CITY OF LOS ANGELES
INTER-DEPARTMENTAL CORRESPONDENCE

15825 W. Roxford St
LADOT Case No. SFV22-113181
LADOT Project ID: 53455

Subject: **UPDATED TRANSPORTATION ASSESSMENT FOR THE PROPOSED ROXFORD STREET WAREHOUSES PROJECT LOCATED AT 15825 WEST ROXFORD STREET (PAR-2020-4386-CM)**

Conceptual Site Plan

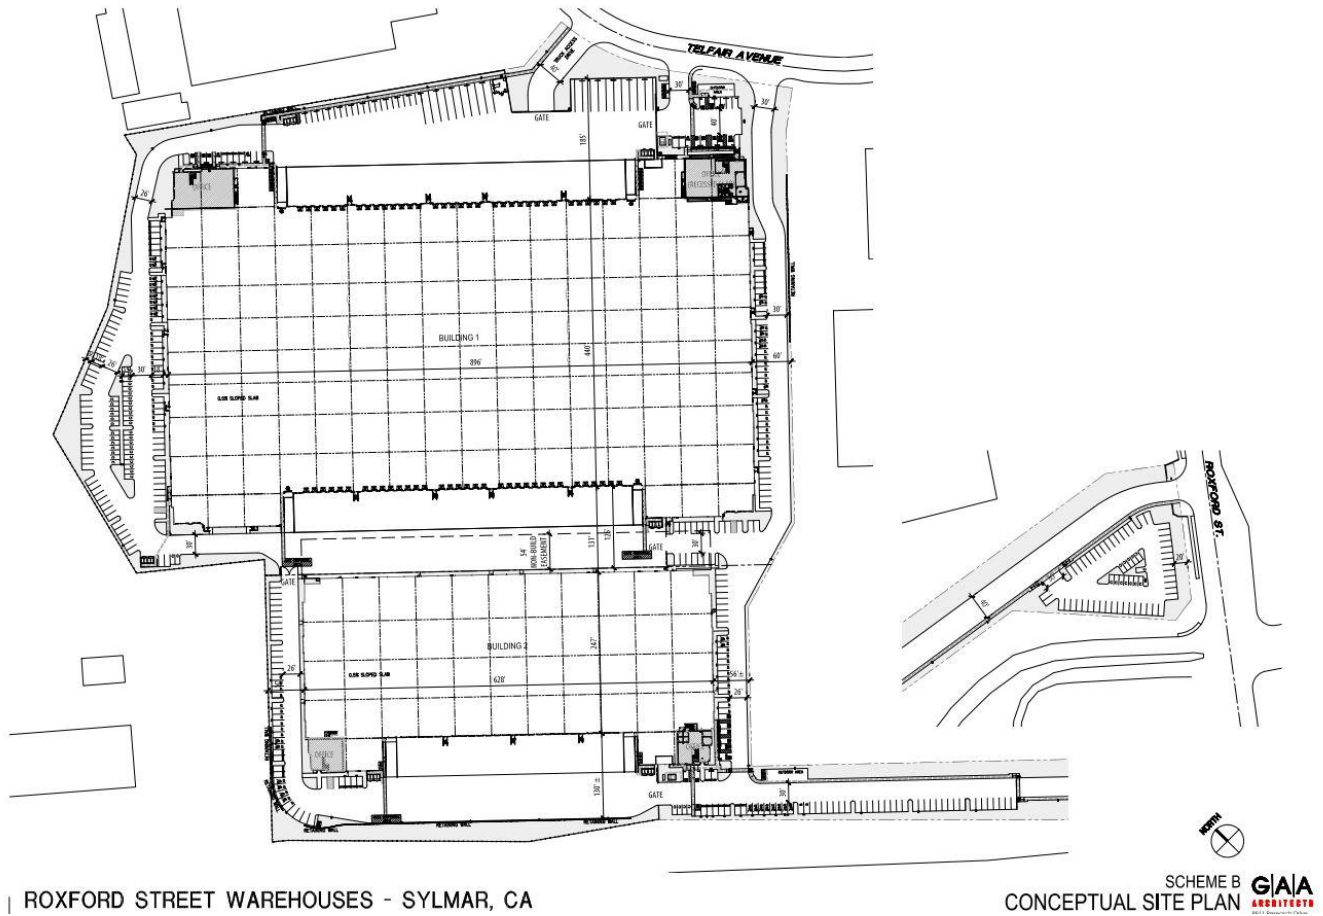
Vehicular access to the project site will be provided via one access driveway on Roxford Street and three access driveways on Olden Street. The north driveway on Olden Street will serve truck traffic for Building 1 only. The central driveway on Olden Street will serve passenger cars for Building 1 only. The south driveway on Olden Street will serve passenger cars and truck traffic for Building 1 as well passenger car traffic for Building 2. The driveway on Roxford Street will serve both truck and passenger car traffic for Building 2 only. The review of this study does not constitute approval of the existing driveway dimensions, access, and circulation scheme with regard to this project. Those elements require separate review and approval and should be coordinated with LADOT's Valley Planning Coordination Section (6262 Van Nuys Boulevard, Rm 320, @ 818-374-4699). To minimize and prevent last-minute design changes, the applicant should contact LADOT before the commencement of building or parking layout design efforts, for driveway width and internal circulation requirements. New driveways should be Case-2, designed with a recommended width of 28 feet for two-way operations, or 16 feet for one-way operations, or to the satisfaction of LADOT. Additionally, the applicant should check with City Planning regarding the project's vehicular access and design.
